RINGERS
SHOP PROCEDURE

1.01 This addendum to Issue 2 of this section deletes the disassembly and assembly procedures for the Type 46A Miniature Straight-Line Ringer and the Type 48 Ringer, and adds mechanical adjustment information for the Type 46A Miniature Straight-Line Ringer.

Figure 7. Type 46A Straight-Line Ringer.

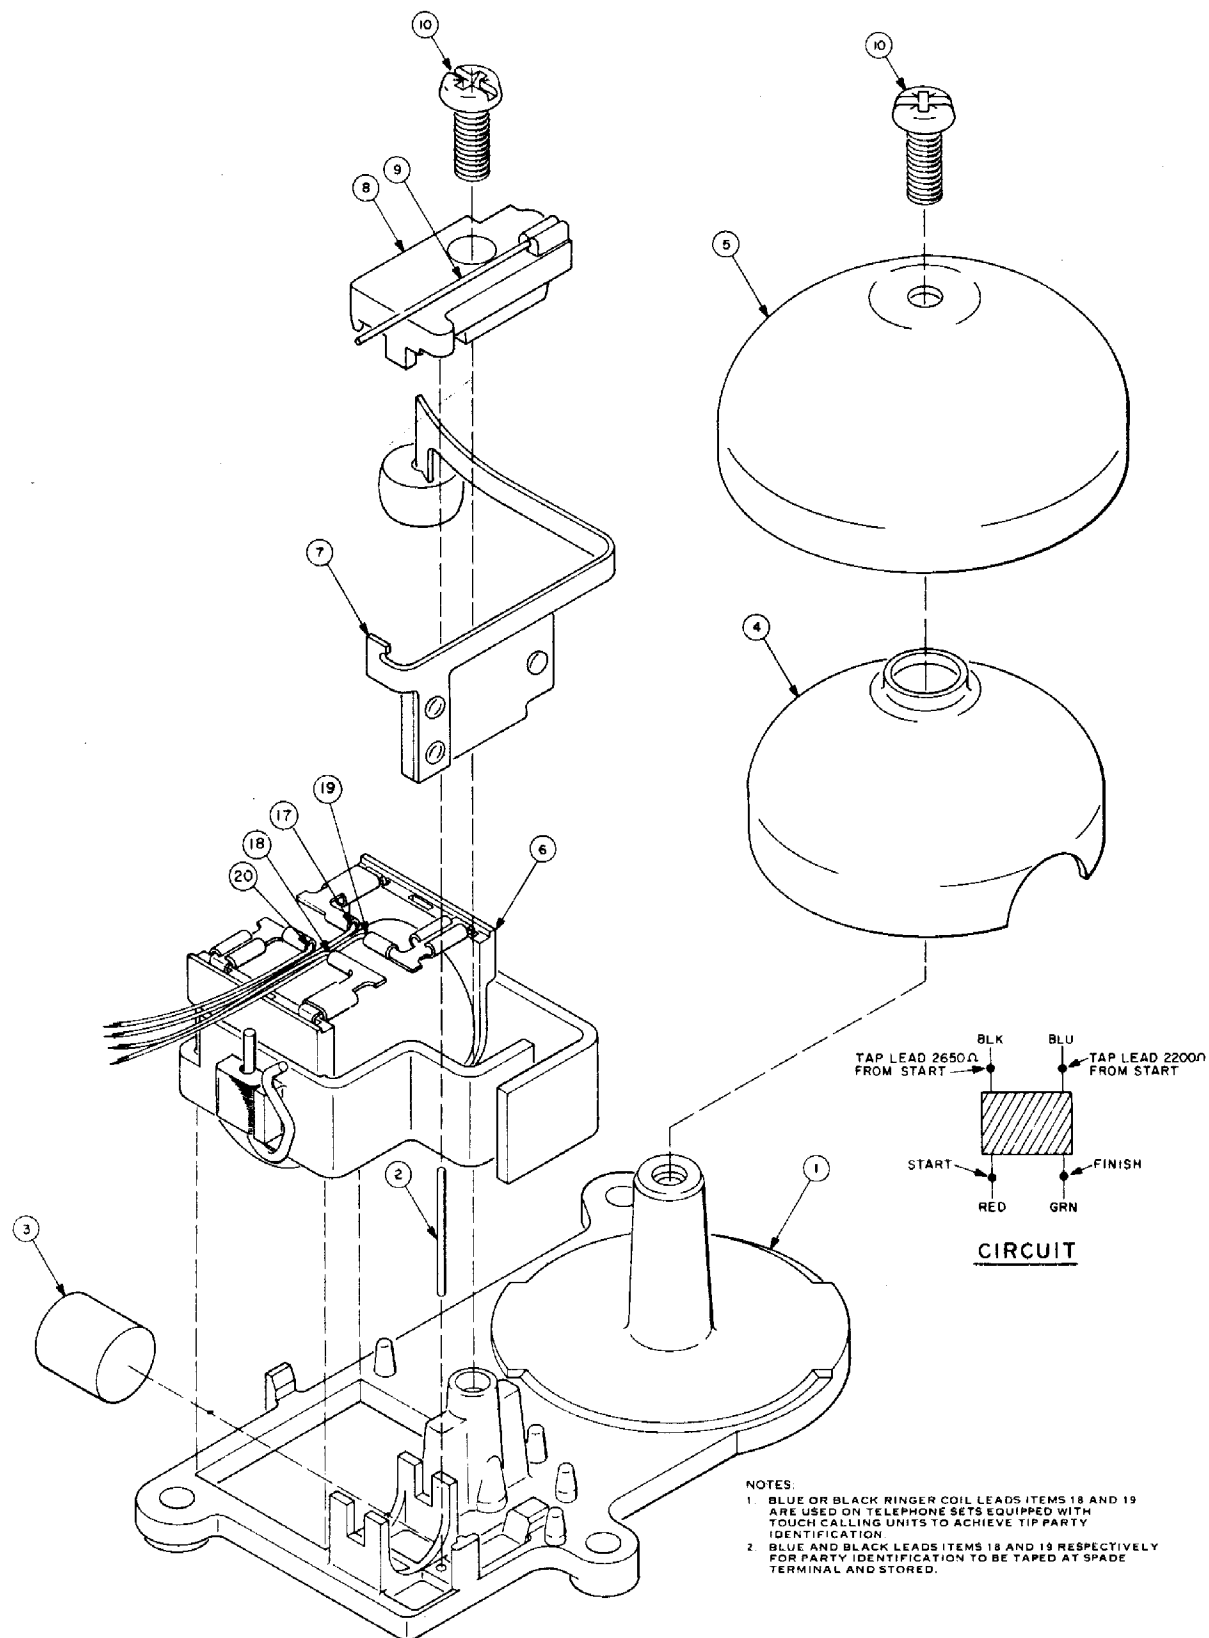
2.02 In paragraph 9.01, delete the last sentence and add the following:

CAUTION: Do not disassemble the Type 46A Ringer. Disassembly causes serious damage to the magnetic circuit.

2.03 Delete the following: in part 9, subpart heading "Disassembly" and paragraph 9.02, and subpart heading "Assembly" and paragraph 9.03.

2.04 On page 25 of 32, after the subpart heading "Adjustment," add the following paragraph:

2.05 Renumber paragraph 9.04 to 9.03, delete the first two sentences, and insert the following:

Ensure that the Type 46A Miniature Straight-Line Ringer meets the following electrical requirements (Table 22):

9.02 Make the following mechanical adjustments to the Type 46A Miniature Straight-Line Ringer:

- (a) Turn the gong clockwise until the clapper-to-gong clearance is between 0.020 and 0.005 inch.
- (b) Free the bias spring from its holder and adjust the spring so that it barely clears the end edge of the holder.

Figure 8. Type 48 Straight-Line Ringer.

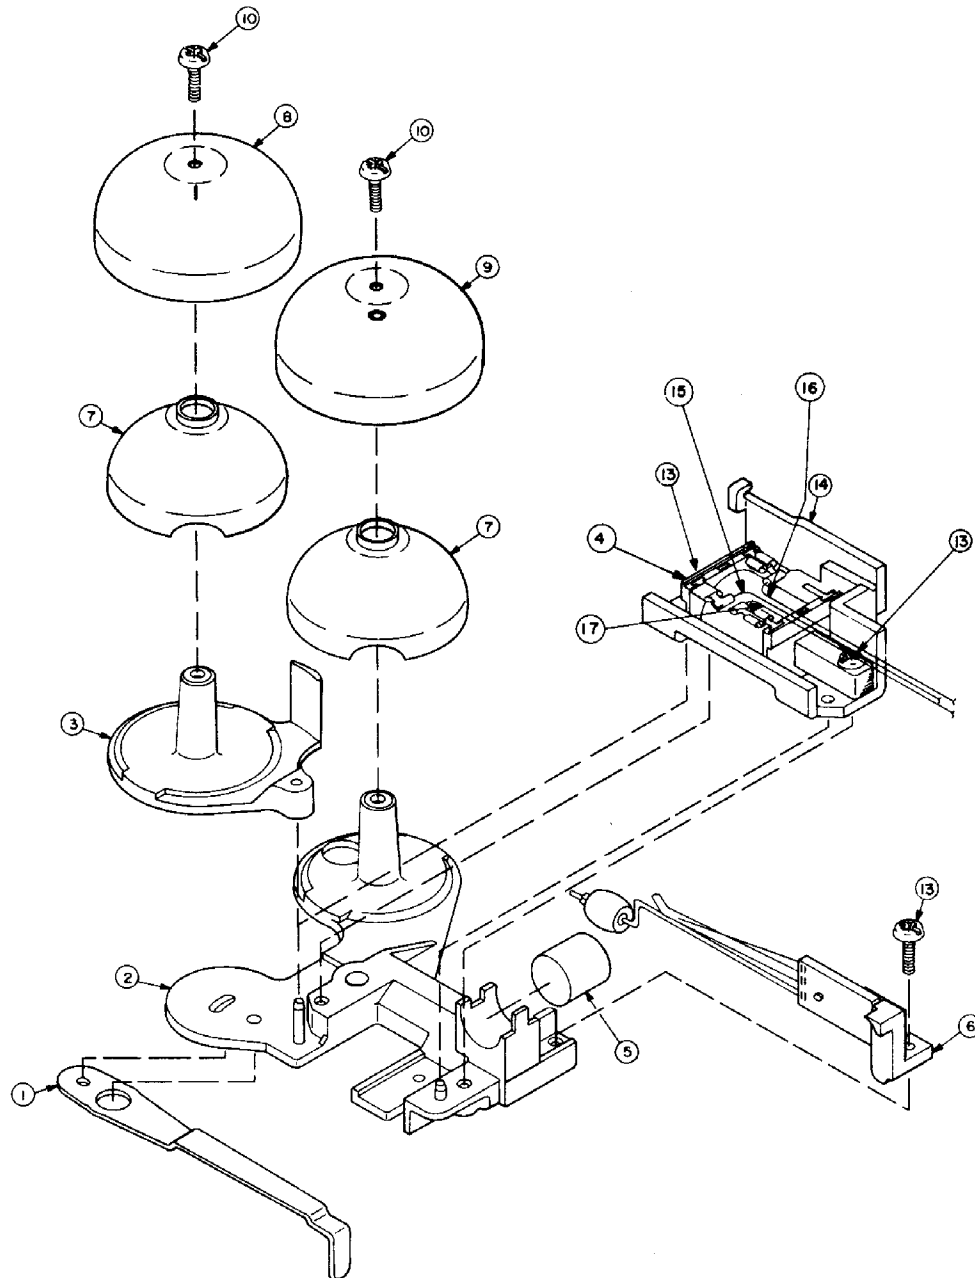
2.06 Delete the last sentence in paragraph 10.01 and add the following:

CAUTION: Do not disassemble the Type 48 Ringer. Disassembly causes serious damage to the magnetic circuit.

2.07 Delete the following: in part 10, subpart heading "Disassembly" and paragraph 10.02, and subpart heading "Assembly" and paragraph 10.03.

2.08 Renumber paragraphs 10.04 and 10.05 to 10.02 and 10.03, respectively.
